Seattle Design Commission

MINUTES OF THE MEETING

6 May 2004

Projects Reviewed

Proposed View Platform

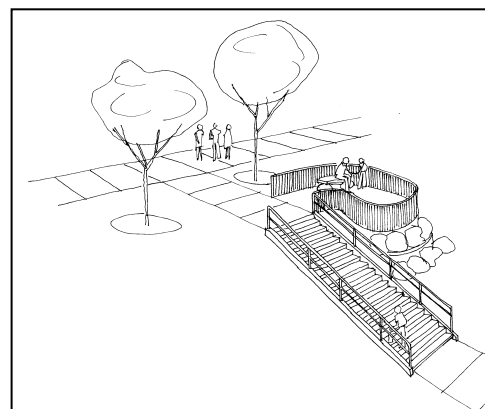
- Has the applicant determined what invasive plants there are in the right-of-way and if removing the plants in the right-of-way – even if they are invasive – would mean a loss of habitat for local wildlife?
 - Applicants said there are morning glory (*calystegia sepium*), ivy (*hedera hibernica*), blackberry (*rubus laciniatus*), and holly bushes (*ilex aquifolium*) in the right-of-way.
- In order to properly evaluate the proposal, we need to know the size of the buildings that will be proposed and how they will affect the views from the viewing platform. Also we need to know what will be planted on the planting strip between the building and the stairs.

- Applicants said that he would probably build a 2 story building with a basement.
- With the ability to build to 35 feet, the potential exists that the viewpoint would be blocked.

- Applicants said that they would be willing to enter into a covenant to restrict the height of the house.
- It is troubling to build into the right-of-way.

- The stairs in question are part of a network of stairs in the area. The stairs are charming, and since they are on a steep slope, they are the “highest and best use” of the right-of-way. Placing a building 5 feet from the stairs would create a radically different experience. The benefits of the platform do not outweigh the benefits of the existing stairs.

- The viewing platform might not bring in more people to the area, therefore there is little benefit to the public.
 - Applicant said the existing stairs were not well used. However, the viewing platform could be used both year-round, and for special events such as SeaFair.

- Concerned that if the viewing platform is deeded to the city without maintenance funds, the platform would not be maintained.
- If the city does need this land in the future, it will be difficult and costly to do so -- it is not easy to condemn land in Washington State.

Jefferson Park Grading and Turf Layout Plan

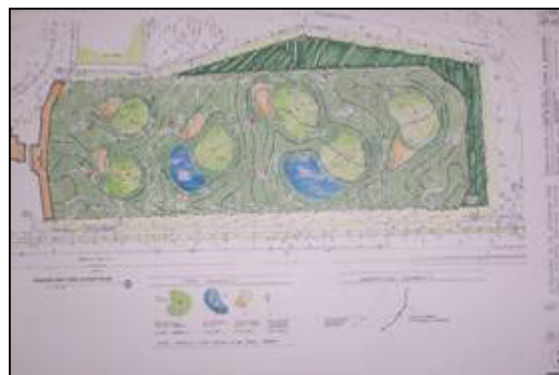
- What opportunities exist for a more natural drainage system? Why would you be looking at artificial turf and not grass?
 - Artificial turf is cheaper to operate.

- Is it a financial decision to use artificial turf?
 - Artificial turf is cheaper to operate but grass is cheaper to install.
- What are the sustainable components?

- No money in budget to landscape buffer or add a trail; perhaps could be done in Phase II.
- Look at a cost/benefit of natural grass vs. artificial turf. The amount of green space in the city is small and ever diminishing; do we want to start permitting artificial turf in parks?

- Consider grading the range when fixing the drainage system.
- Think more adventurously about the poles and nets, like perhaps adding flags, changing the color at a high level, adding stencils to the nets, and including a periscope in one of the poles.

Jefferson Park Conceptual Lighting Plan

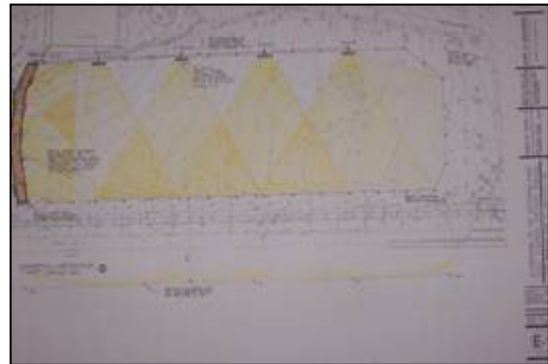
- The community should have a say in the poles' design.
- Don't use chemicals or fertilizer.
- What is the impact of the nets on birds?
 - Called other operators, and they don't have problems.
